**City of Aurora Building Division**
**Project:** *HCA ACADEMIC RESIDENCY OFFICE*
**Address:** *1400 S POTOMAC ST Unit 200*
**Occupancy Group:** *IBC B*
**Construction Type:** *UBC II-N-SPK*
**RSN:** *1652123*
**Permit:** *22-2201757-LT*

**City of Aurora Building Division**
**Reviewed for Code Compliance**
**Approved as Noted:** *Matt A.*
**Date:** *Aug 23, 2022*
2015 INTERNATIONAL CODES & 2020 NEC

# HCA Academic Residency Offices

# CONSTRUCTION DOCUMENTS

A1 **LIFE SAFETY PLAN - LEVEL 2**
1/16" = 1'-0"

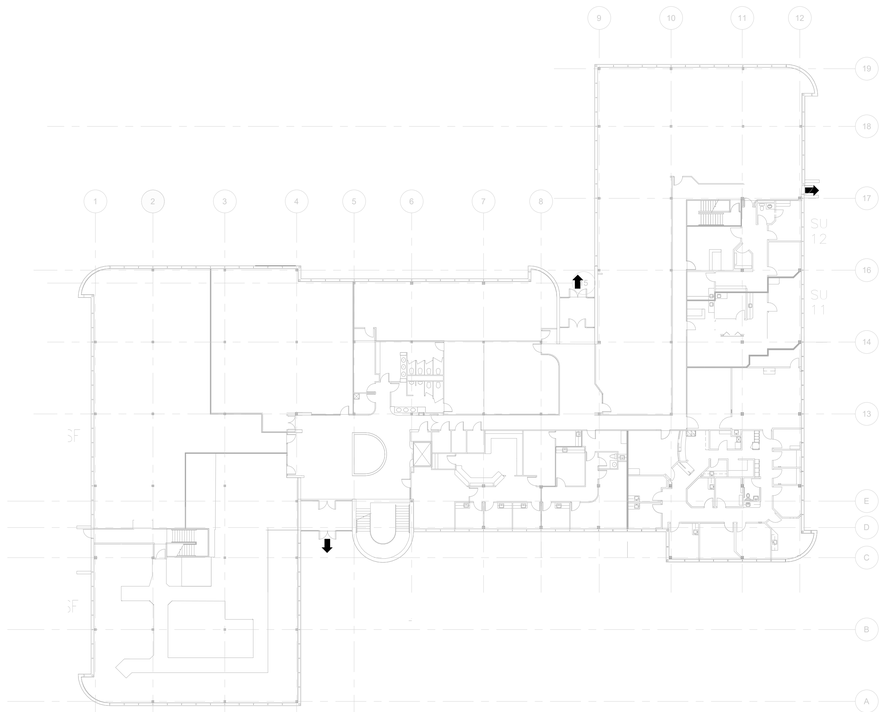
AT ALL TIMES DURING CONSTRUCTION, MAINTAIN REQUIRED EXITS, EXISTING STRUCTURAL ELEMENTS, FIRE PROTECTION AND SANITARY GUARDS PER **2015 IBC 3302.1**

A4 **LEVEL 2 - DEMO FLOOR PLAN**
1/8" = 1'-0"

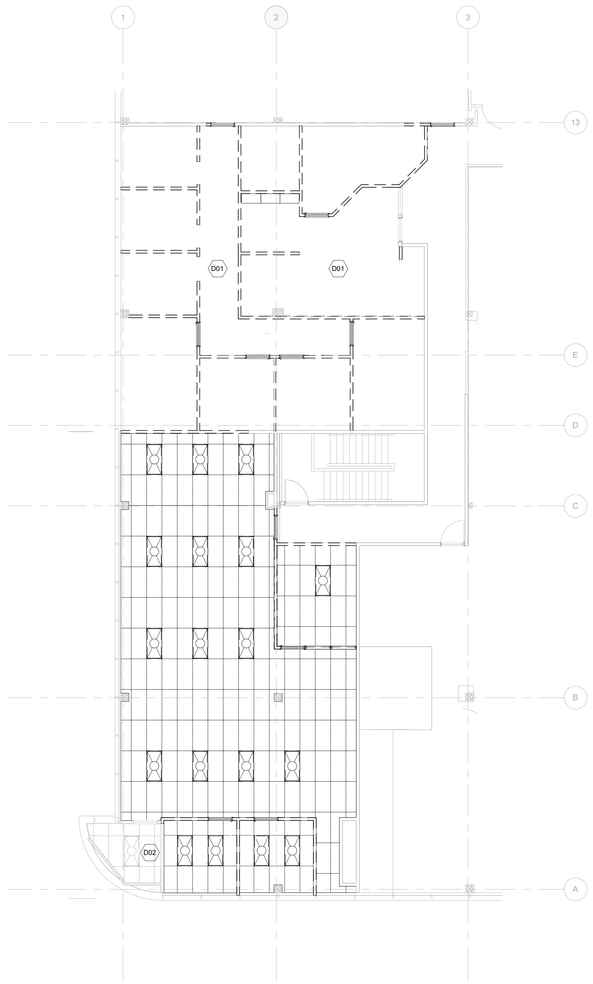
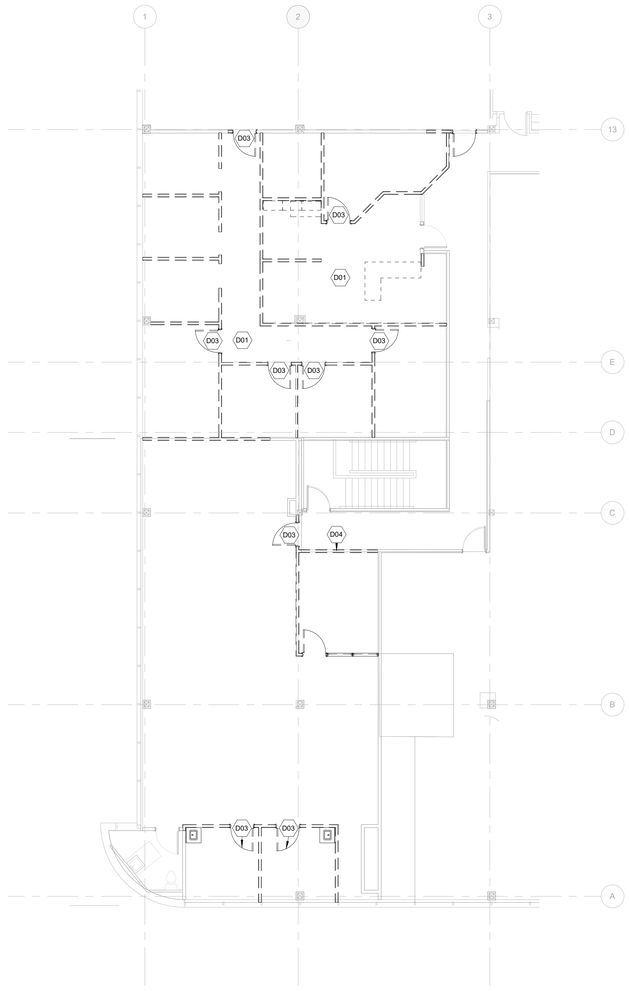
Provide a sign stating "EXIT" in raised, visual characters and braille adjacent to each door in an area of refuge, an exterior area for assisted rescue, an exit stairway or ramp, an exit passageway and the exit discharge. **2015 IBC 1013.4**

## PLUMBING NEW PLAN 2

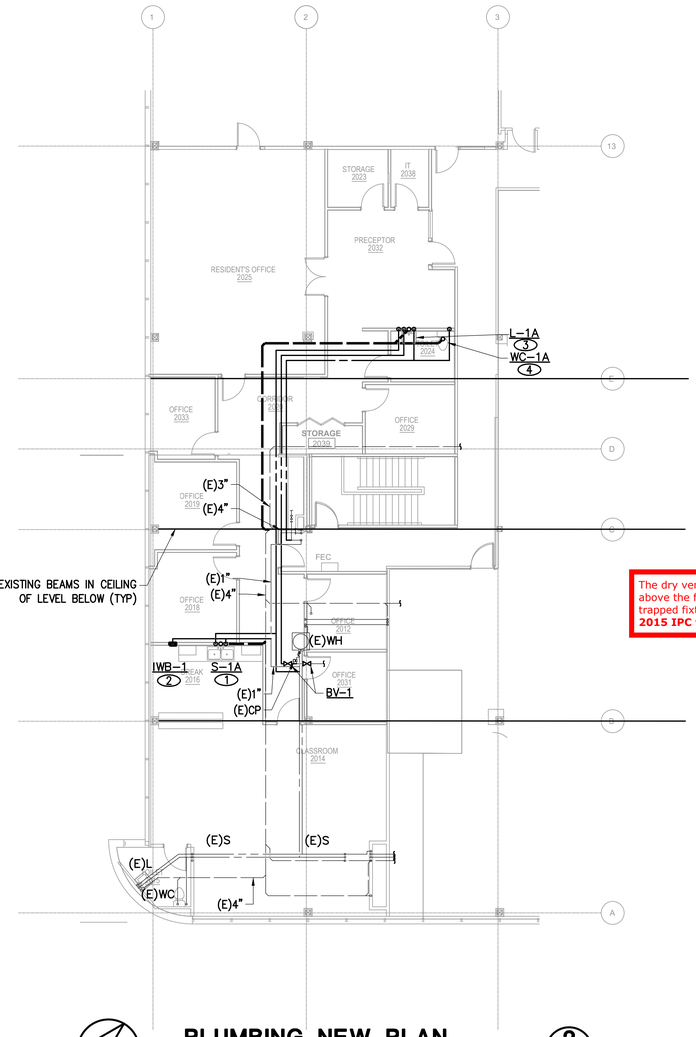
The dry vent must rise 6" vertically above the flood level rim of the highest trapped fixture being vented. **2015 IPC 905.4**

## MECHANICAL NEW PLAN 2
1/8" = 1'-0" M102

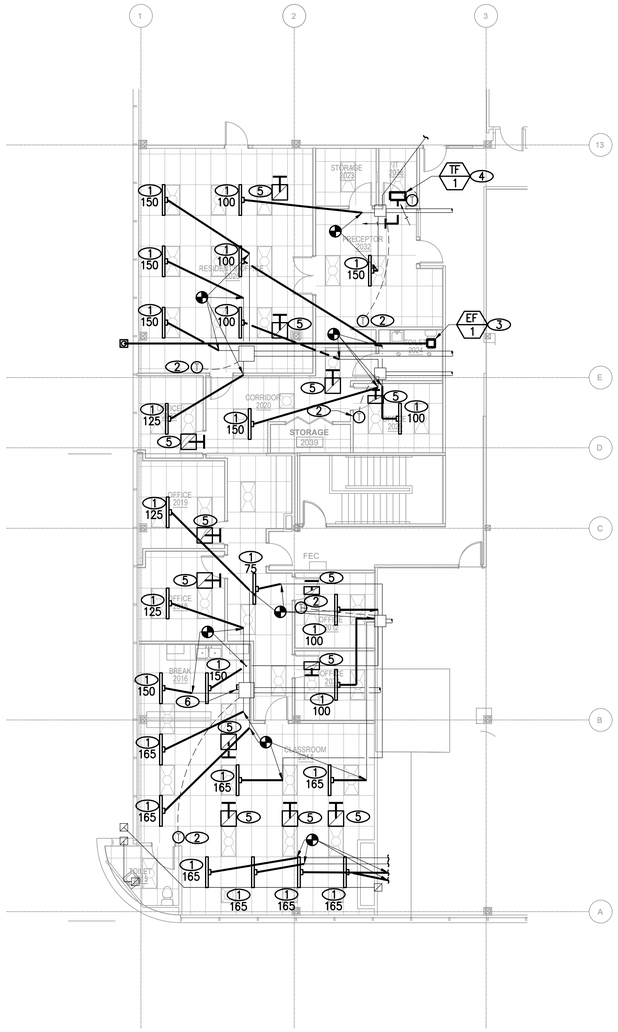
Plastic fire sprinkler piping exposed within a plenum shall be used only in wet pipe systems and shall have a maximum: peak optical density of 0.50; average optical density of 0.15; flame spread of 5 feet in accordance with UL 1887. Piping shall be listed and labeled.
**2015 IMC 602.2.1.2**

Provide proof of a flame spread less than 26 and a smoke development less than 50 for any material used in a plenum.
**2015 IMC 602.2.1**

E2 **LEVEL 2 - OVERALL POWER PLAN**
1/8" = 1'-0"

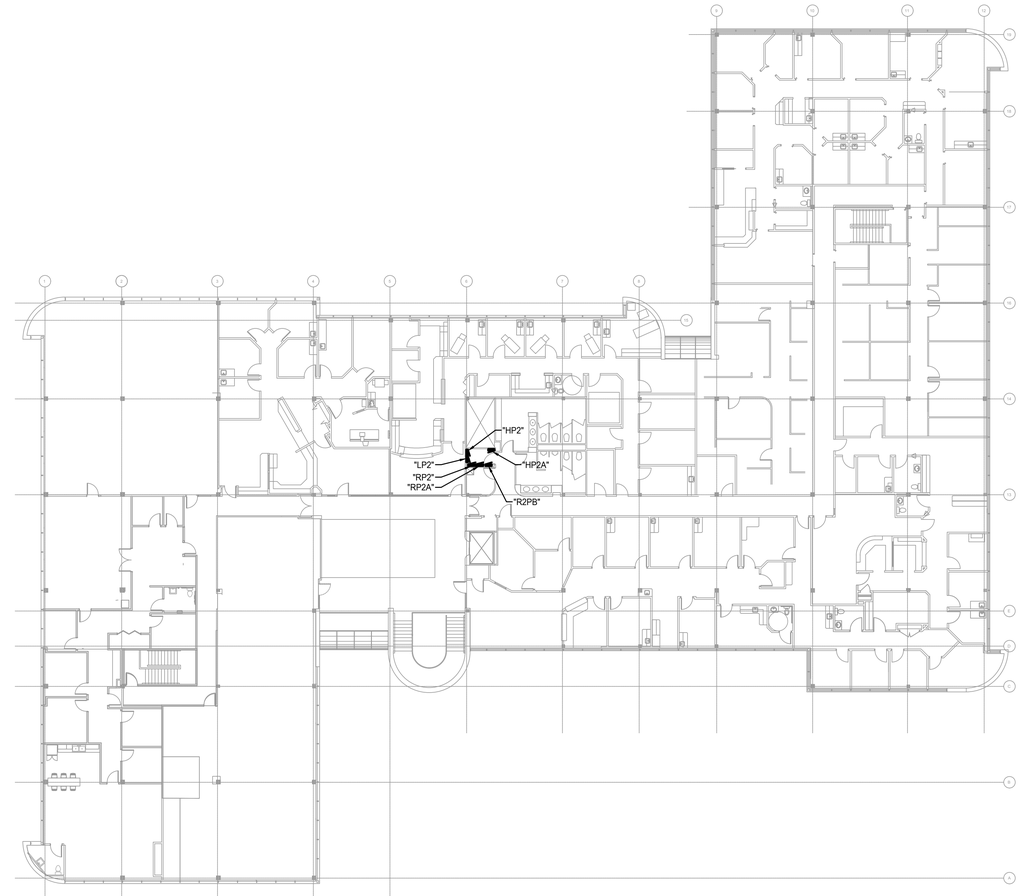
Install electrical connections per 2020 NEC 110.14, Identify disconnects per 2020 NEC 110.22 and provide working space around Electrical equipment per 2020 NEC 110.26

E1 LEVEL 2 - POWER PLAN
1/8" = 1'-0"

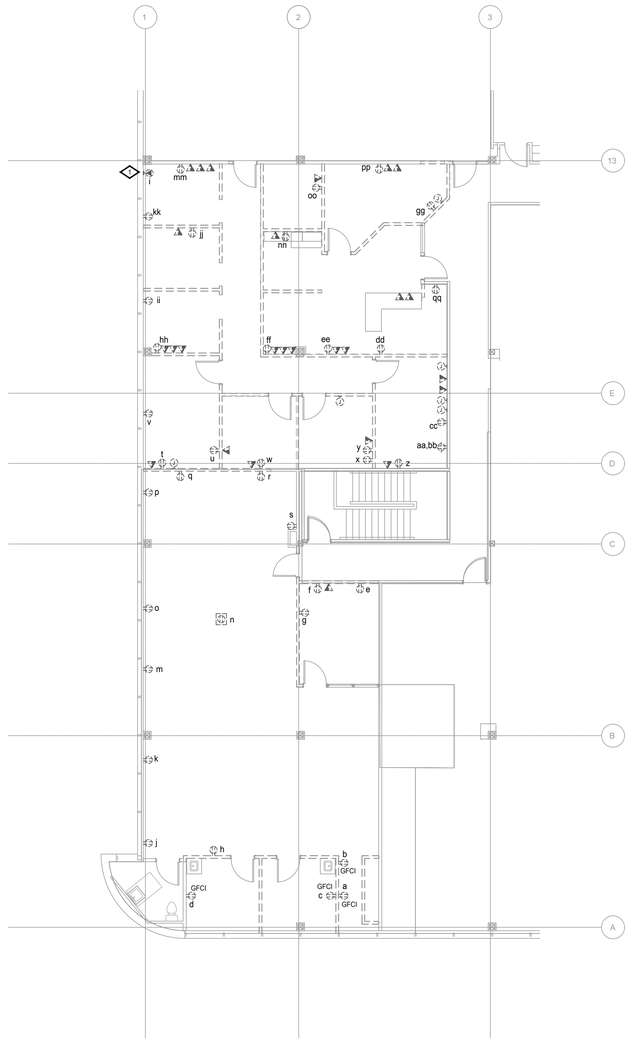
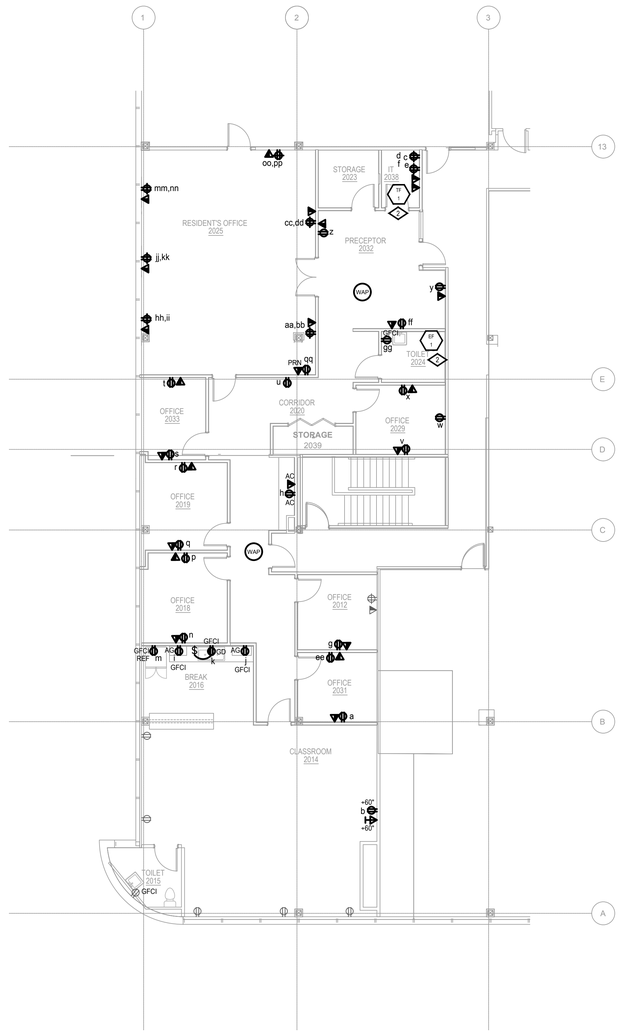
Install electrical connections per 2020 NEC 110.14, Identify disconnects per 2020 NEC 110.22 and provide working space around Electrical equipment per 2020 NEC 110.26
